Design process

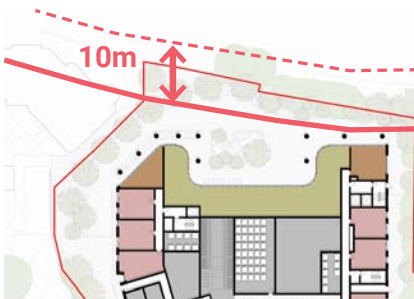
19

Add trees in front of building on Vastern Rd. Planting to consider 30:20:10 ratio (Family:genus:species).

Street trees could be added as part of 278 works. Two additional trees have been proposed within the foot-way along Vastern Road tying into the existing pattern of tree planting. To be agreed with the local authority as part of the 278 works.

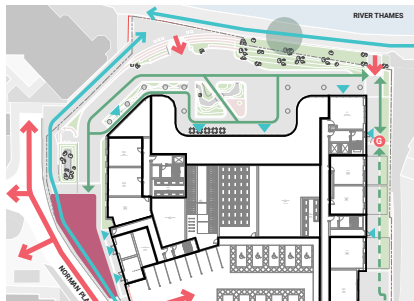
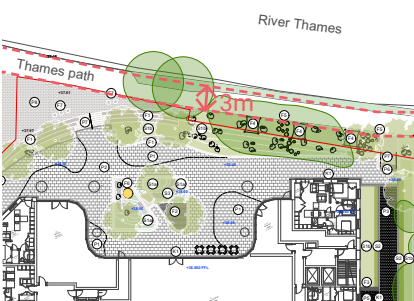
21

Should provide further justification for not widening National Cycle Network route 5 given it does not meet standards.

Widening of the route along Norman Place to be incorporated within site boundary although a balance needs to be struck with providing active frontage at ground floor in the form of residential homes with defensible space and the widths required for the pedestrian and cycleway.

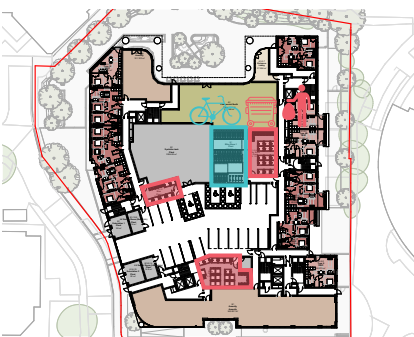
22

EV charging and car club - All car parking spaces should have access to an EV charging point. Dedicated car club to be provided on site.

Cycle storage - To be provided in accordance with Council's standards. Convenient access to be demonstrated.

Bin storage/collection - Collection strategy to be demonstrated to avoid obstruction of footway/cycleway.

Access to EV charging points is supported and will be provided.

Proposals designed to meet councils standard.

Refuse presentation zone will be designed to avoid obstruction to public thoroughfares. Refuse stores reduced through management of weekly collection.

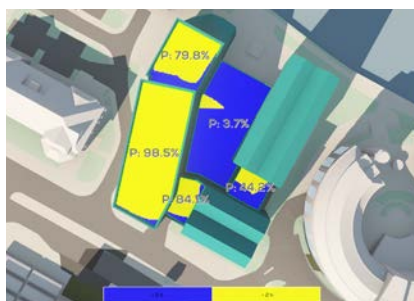
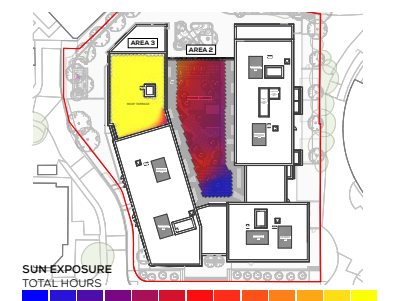
25

Daylight/sunlight/overshadowing - Results to be tabulated as opposed to being a visual representation to confirm NSL/VSC results. Assessment for adjoining development land to be submitted. Daylight factor or interior illuminance to be assessed for internal courtyard apartments. Only 3.7% of the main courtyard space at first floor level would achieve the BRE recommendation of receiving 2 hours of sunlight on 21st March - significant question the use, function, value and benefit of this space

Further testing has shown that overall, 56% of the total open space provided sees two or more hours of direct sunlight on 21st March, exceeding the BRE recommendation of 50%. The proposed development offers future residents and visitors good access to a variety of well sunlit communal open spaces to enjoy throughout the year.

Initial wind test diagram

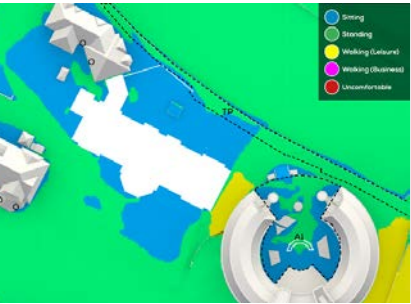
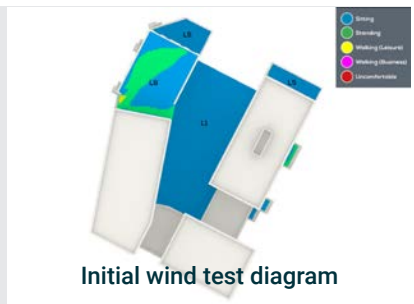
26

Wind - Rationale for CFD test as opposed to wind tunnelling to be demonstrated. Testing to include cumulative schemes.

CFD test was considered appropriate and allowed for the design to be developed following the first iteration of testing. The balustrade was updated from a railing to a solid balustrade to improve conditions to the terrace level.

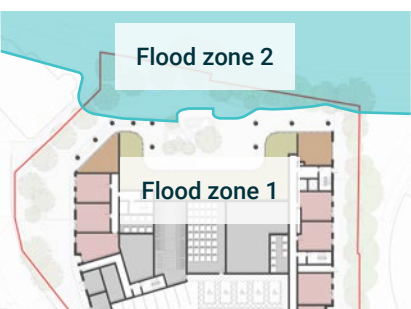
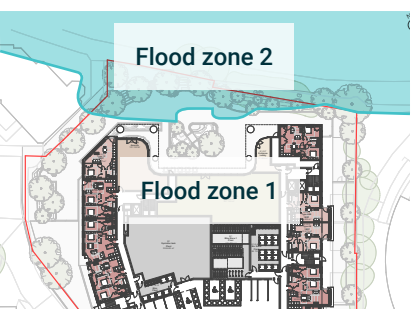
27

Flood Risk - If the Environment Agency (EA) subsequently signal agreement with suggested approach (essentially to reclassify the site as Flood Zone 1), then following the national guidance the sequential and exception tests would thereafter not apply.

Noted. All built form sits within Flood Zone 1. Changes to boundary treatments provide further drainage capacity and betterment

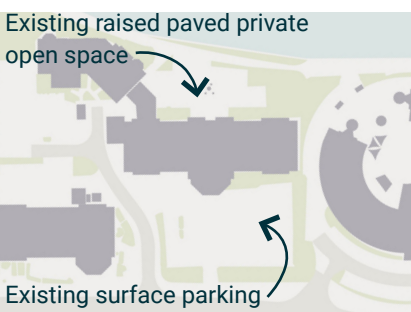
28

Ecology - 10% biodiversity net gain to be demonstrated. Wildlife-friendly lighting strategy to be submitted.

Significant planting and greening of the public realm, residents courtyard gardens and roof terraces, which will meet the 10% onsite BNG policy requirement

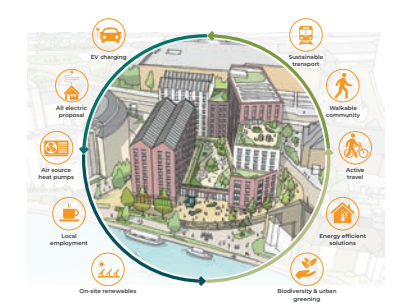
31

Energy - Evidence required to demonstrate why GSHP has been discounted and inclusion of ASHP. Water-based energy solution to be explored. Investigate District Heat Network within close proximity. Justification re why zero carbon emission rating is not thought required.

GSHP and water-based energy solution comes at a greater cost, which would impact upon scheme viability and the delivery of affordable housing. Infrastructure is outside of ownership boundary.
